**Context of Proposed  
Zoning Change on  
Property at  
2810 Weissinger Road**

Project 19ZONE1017  
(9121 Blossom Ln)

**19ZONE1017**  
**Context Views**  
**Langdon Place Neighborhood**

## Views of 2810 Weissinger Rd - Property Line at Project 19ZONE1017 L

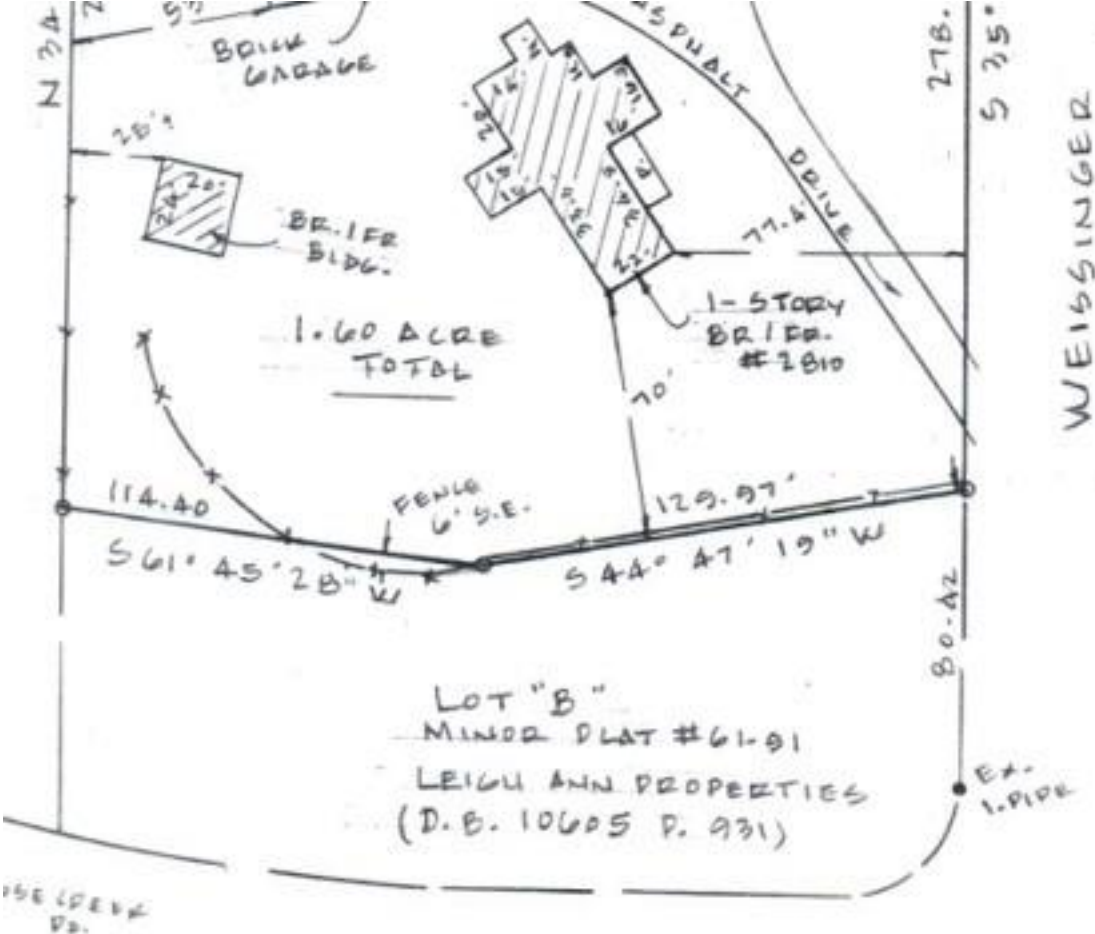
View from south property line of Jesse Murray House. Location needing enhanced landscape buffering as per UDStaff:

“The Jesse Murray house, (JF 501) is located at 2810 Weissinger Road. Staff recommends protecting the context of the house with tree preservation and landscape buffering.”

# Clearing Outside the Limits of Disturbance

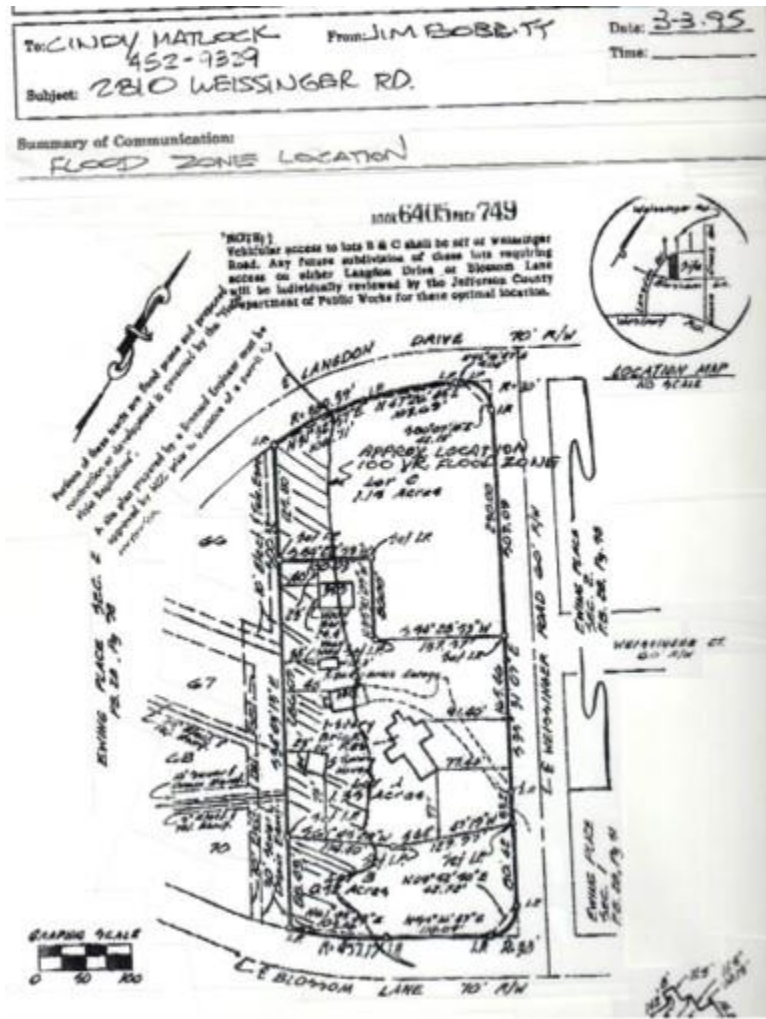
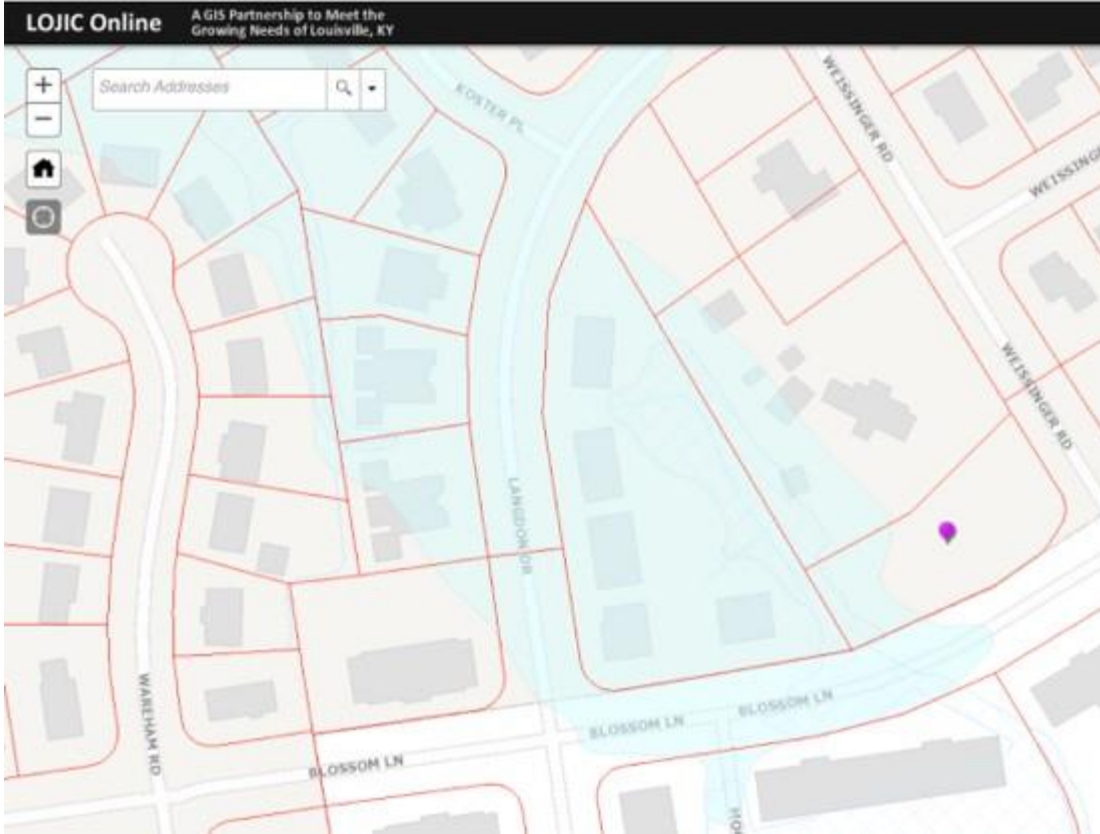
Tree clearing  
and remaining  
wood stacked  
against Colliver  
fence  
in September  
2017
